PE12-019

July 6, 2012 - Internal Mazda  
communication regarding  
NHTSA question of Mazda  
update.

**SUBJECT:** Safety Recall 04S25: *Update*  
All 2002 through 2004 Model Year Left Hand Drive (LHD) Escape Vehicles Equipped  
with 3.0L Engines  
Accelerator Cable Replacement

**SUBJECT:** 2002-2004 Tribute Accelerator Cable Safety Recall 2704L – UPDATE

FIGURE 1

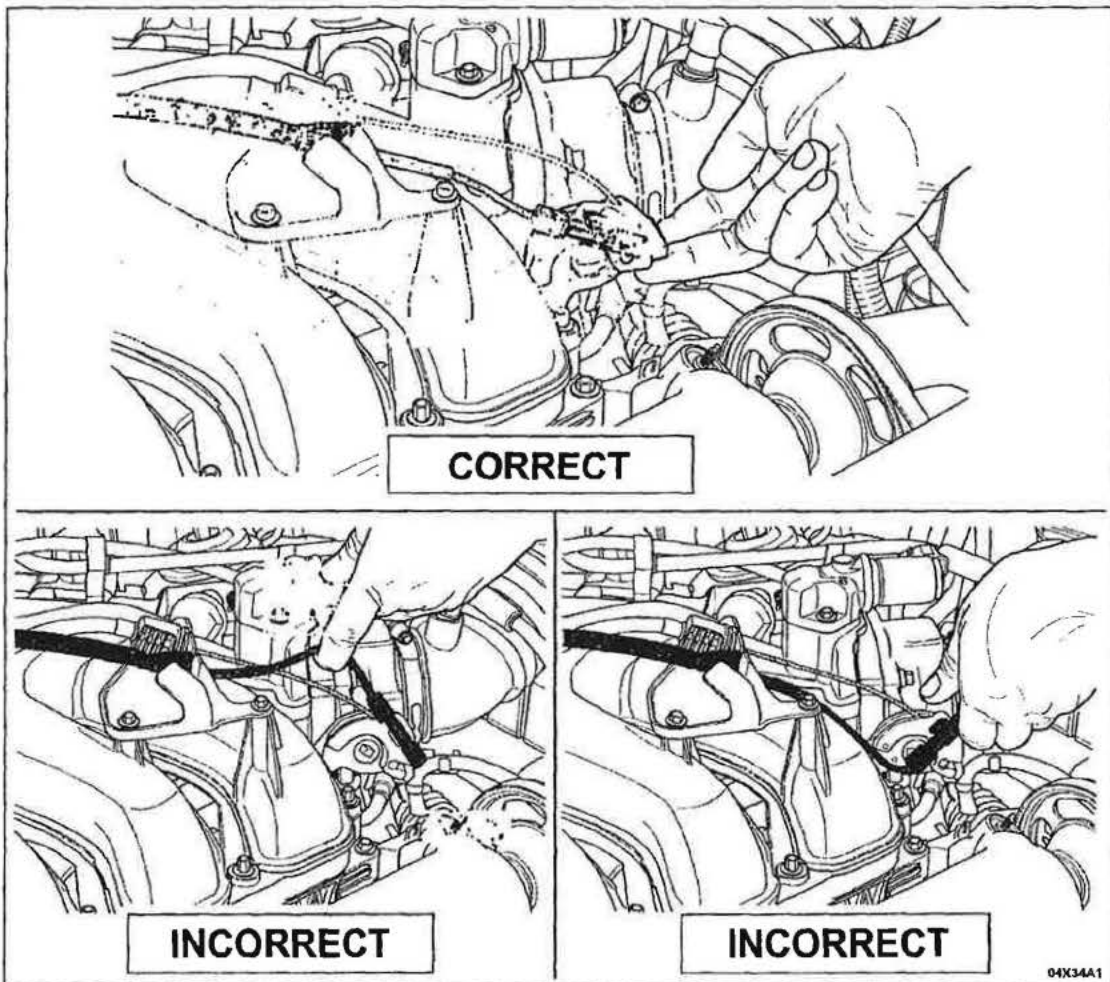
**NEW**

**CAUTION:** Damage to the speed control cable may result if the throttle body cam is rotated by lifting up on the speed control cable or the speed control cable connector end. When disconnecting the accelerator cable from the throttle body, rotate the throttle body cam only by lifting up on the cam itself. See Figure 1.

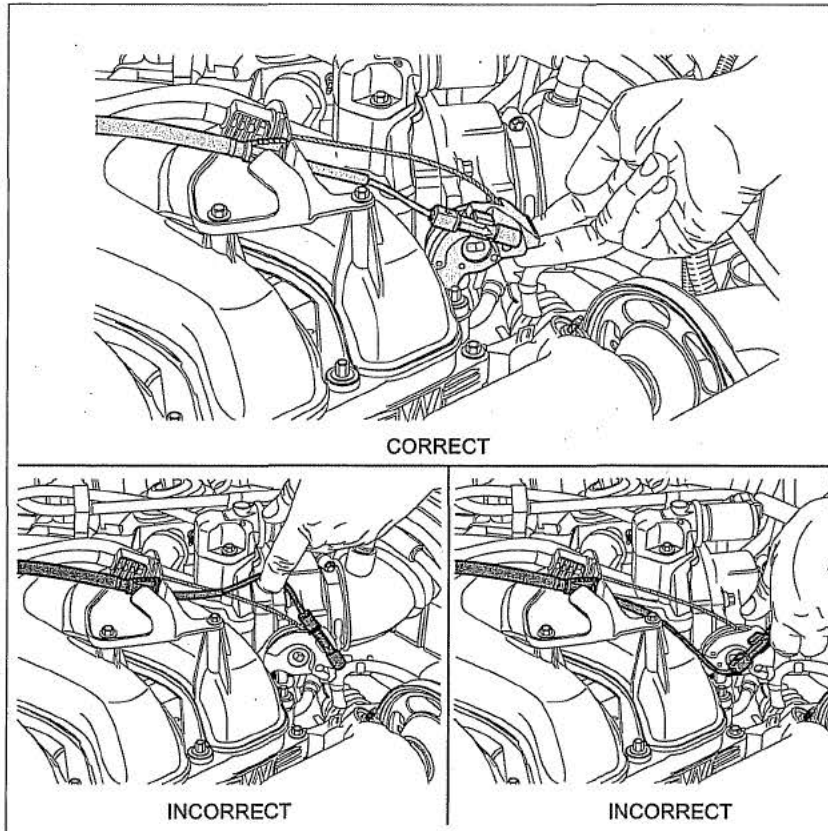
**CAUTION:** Damage to the speed control cable may result if the throttle body cam is rotated by lifting up on the speed control cable or the speed control cable connector end. When disconnecting the accelerator cable from the throttle body, rotate the throttle body cam only by lifting up on the cam itself. See Figure below.

- A CAUTION has been added to the Repair Procedure on page 3 to help prevent damage to the speed control cable while performing the accelerator cable replacement procedure.

FIGURE 1

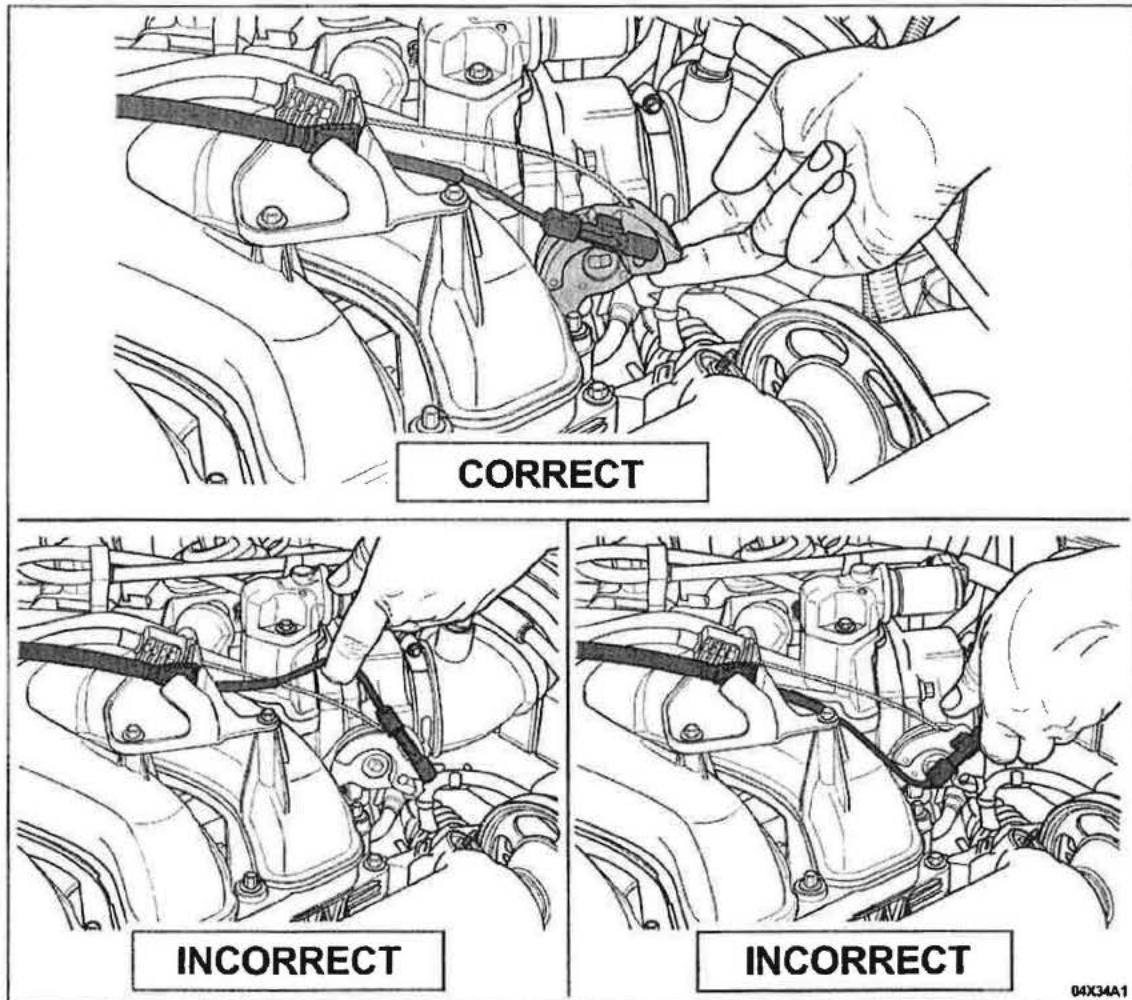
**NEW**

**CAUTION:** Damage to the speed control cable may result if the throttle body cam is rotated by lifting up on the speed control cable or the speed control cable connector end. When disconnecting the accelerator cable from the throttle body, rotate the throttle body cam only by lifting up on the cam itself. See Figure 1.
